Access Compliance Report

Public Rights-of-Way

Intersection ID: 12900	Main Street: ARNOLD_DR	Cross Street: DRAPER_AV	Location: SW
ADA ID: 54D803BBA552	Ramp Type: Perp	Initial Pass/Fail: Pass	Overall Compliance: No
		Severity Score: 35

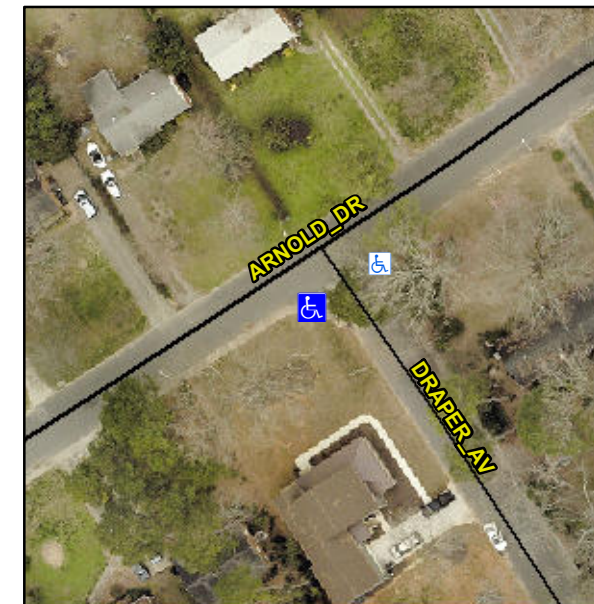
Not Found, R304.2.1, R304.2.2-Perp, R304.3.2-Para, R304.5.3, R305, R302.7.2

Remove & Replace Entire Ramp.
